## MFD NON-COMPLIANCE REPORT # 28049-1

PART NAME: **HOMS M2H CHAMBER/MIRROR ASSY, SPARE, FEE**      DATE: **11/23/11**  
PF/SA NO.: **SA-382-103-54**      INSPECTOR: **E. REESE**  
WORK ORDER NO.: **28049-1**      ENGINEER: **D. RICH**      EXT.: **4637**  
VENDOR: **MFD**      ROUTE TO: **VAC ASSY**

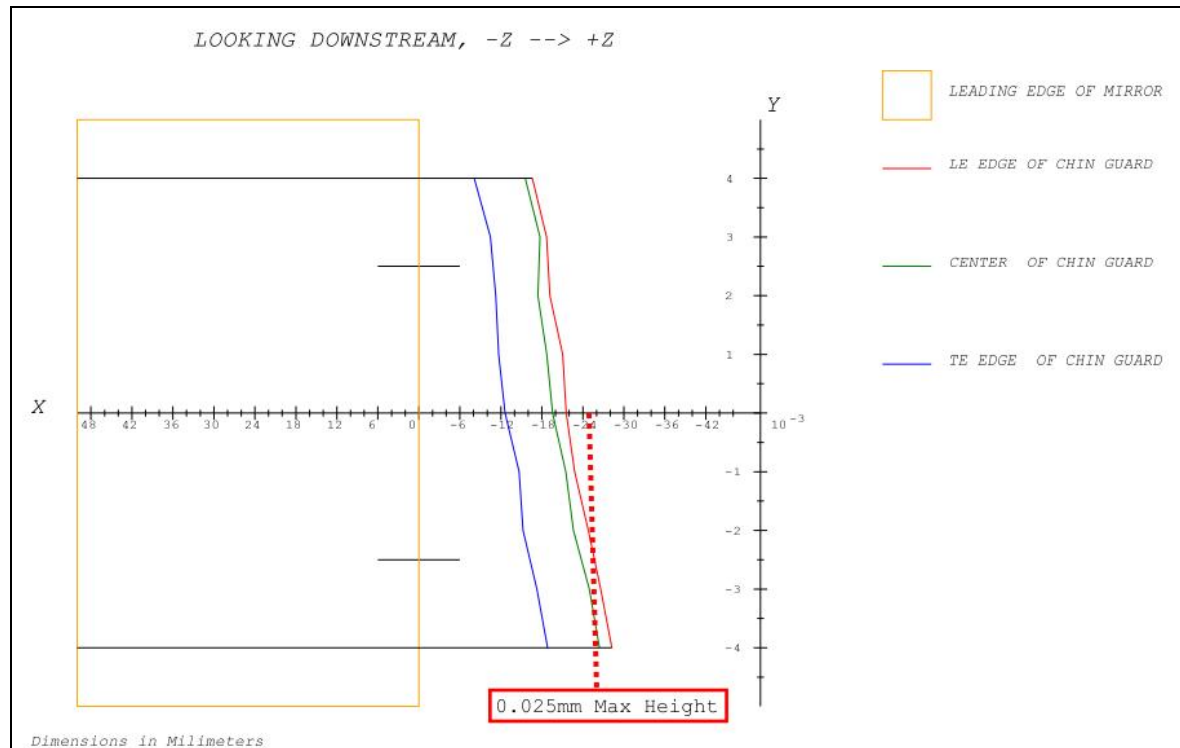
1. Chin Guard exceeds the 0.025mm maximum height above the surface of the mirror. (See Below)
